# KILLOUGH SOLAR FARM - PROPOSED 110KV SUBSTATION

SID FURTHER INFORMATION RESPONSE - AN  
COIMISIÚN PLEANÁLA (Ref. 324132-26)

P24169-FT-XX-XX-RPT-PL-0001

**Figure 2-1: Moycarkey Village Detail: DSM based ZTV map illustrating the degree of terrain and vegetation screening within 1km of the proposed substation**

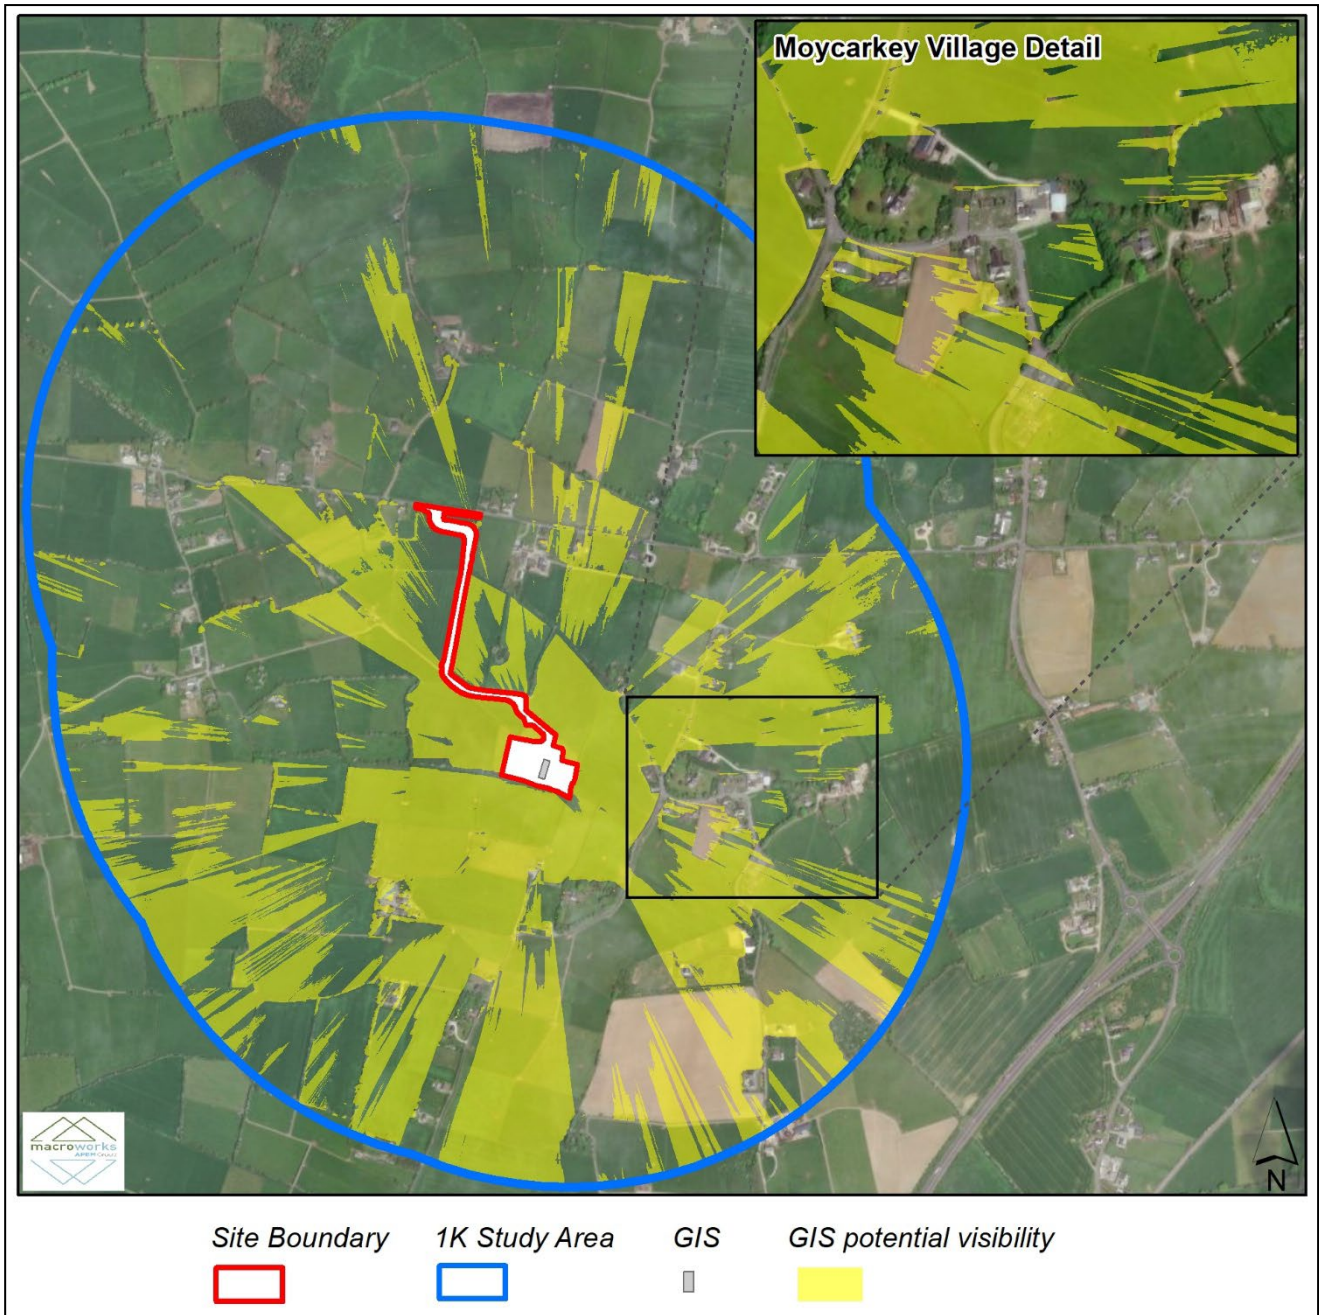
With regard to the landscape and visual impact of the proposed GIS building and perceived impacts on Moycarkey Village and nearby receptors, the Applicant accepts that the proposed location of the substation is closer to Moycarkey village than the original location, and will be more visible as a result. However, assessments conducted by MacroWorks (MW) to determine the Landscape and Visual Impact (LVIA) of the Proposed Development, and, as shown in *Figure 1 - Zone of Theoretical Visibility (ZTV) map*, below, at over 300m away from Moycarkey Village, MW analysis shows the Proposed Development still remains at a discrete distance from the village where it will not be a visually dominating feature or perceived as part of the built fabric of the village.

To illustrate this point, a *Zone of Theoretical Visibility (ZTV) map*, Figure 1, below, has been produced using *Digital Surface Model (DSM)* data which accounts for screening by terrain, vegetation and buildings. This shows the substantial degree of screening afforded by the vegetation lining the western edge of the village. Even for the two residential dwellings that occur on the western side of the road that defines the western edge of the village, there is consolidated screening in the direction of the proposed substation at the property boundary.

It is accepted that the proposed substation is contained in a relatively open rural context with large field and maintained hedgerows that do not provide a strong degree of enclosure. It can be seen from the DSM based ZTV map, Figure 1, above, that relatively open visibility of the proposed substation will be afforded from within the nearest 300-400m in most directions, albeit this area is predominantly contained in agricultural farmland with few dwellings present. However, beyond this distance, the incremental sequences of field boundary vegetation soon precludes visibility or affords only sporadic shards of visibility through vegetation.

Figure 3-1: Extract from the 1905 OS map showing the proposed substation and route of footpath (highlighted in green)

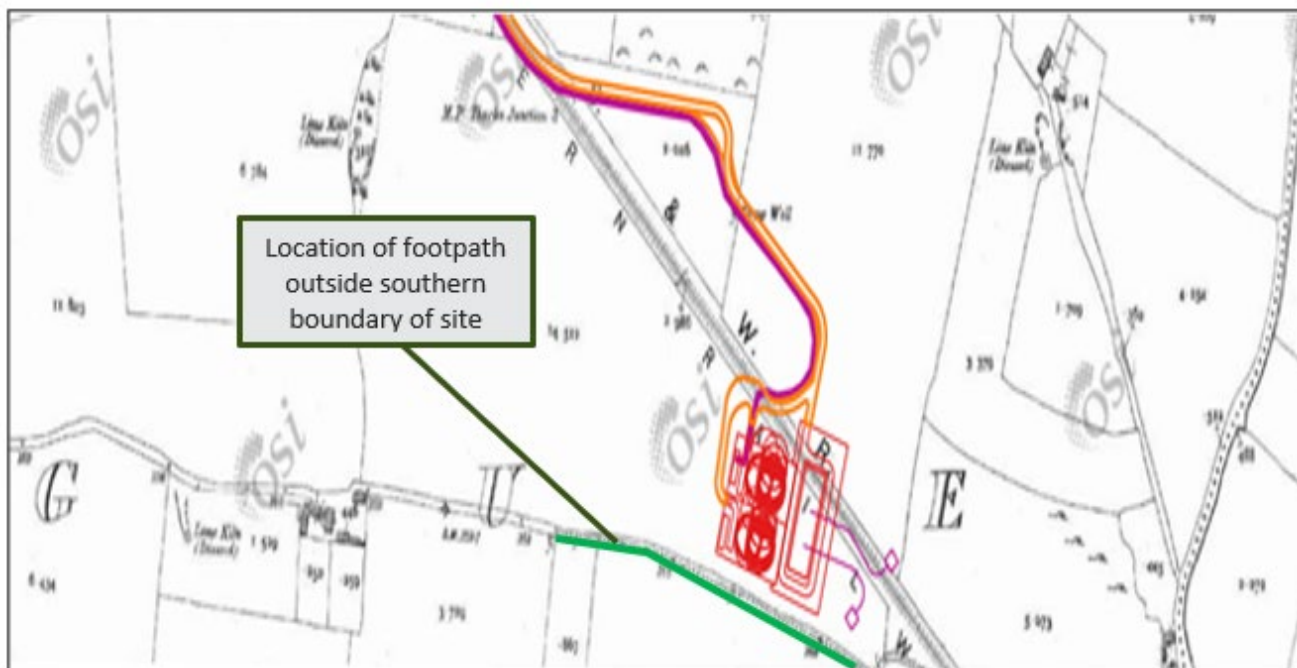
With regard to the appellants reference of a 'Mass Path', IAC Archaeology conducted a review in preparation of this response, and note a footpath is shown on the 1905 Ordnance Survey map, which runs in an east-west direction to the immediate south of the field boundary that forms the southern boundary to the Proposed Development area, as shown in Figure 2-3, below.

Footpaths are not generally included in heritage assessments, unless they have a specific designation, as they form part of the landscape in the same way roads and field boundaries do. In this instance, the footpath slightly cuts the corner of the field that forms the southeast corner of the development area, but it is not located within the footprint of the proposed substation site. The footpath is not marked on the first edition Ordnance Survey map of 1843, although it is possible an earlier road once ran along this alignment to Moycarkey village, as suggesting in the mapping. This is not unusual, when old roads go out of use.

IAC Archaeology state that no documents have been identified that identify this former footpath as a "Mass Path". It is not marked as such within the historic mapping and no records of it were identified during a review of the National Folklore Collection.

**Figure 9-1: Delivery Route**

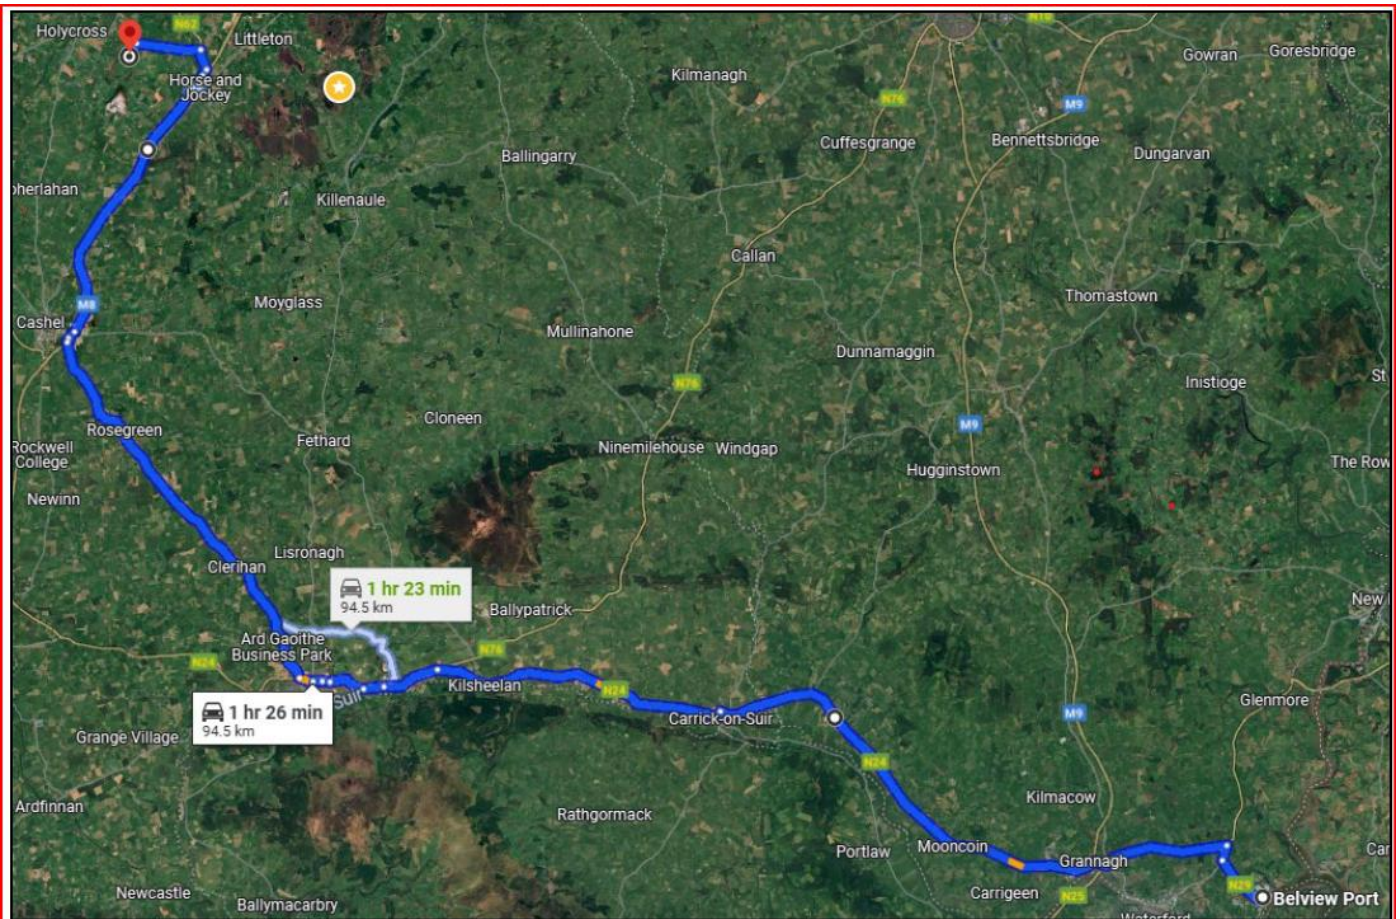
**Response from MLavelle: Sweptpath analysis is not included with application for long vehicles from Port. Neither is an assessment of bridges or roads to carry heavy loads & cranes. Note the recent issue with generators & the West Link Bridge on the M50.**

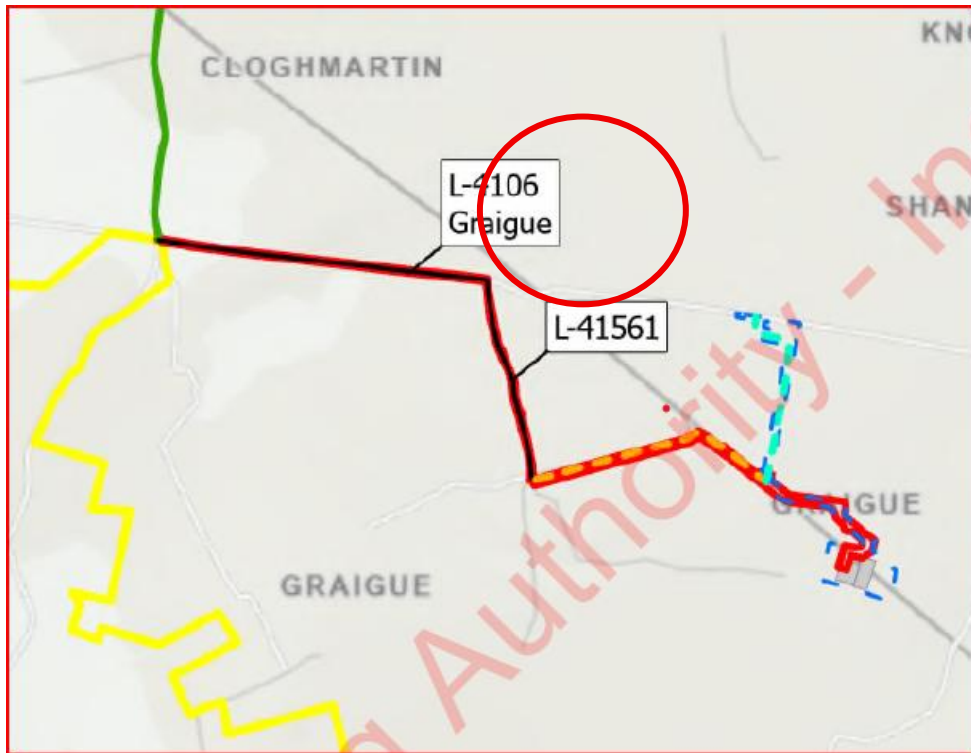
CEMP Map: Note Road numbers are incorrect & this is repeated throughout the application & the previous application.
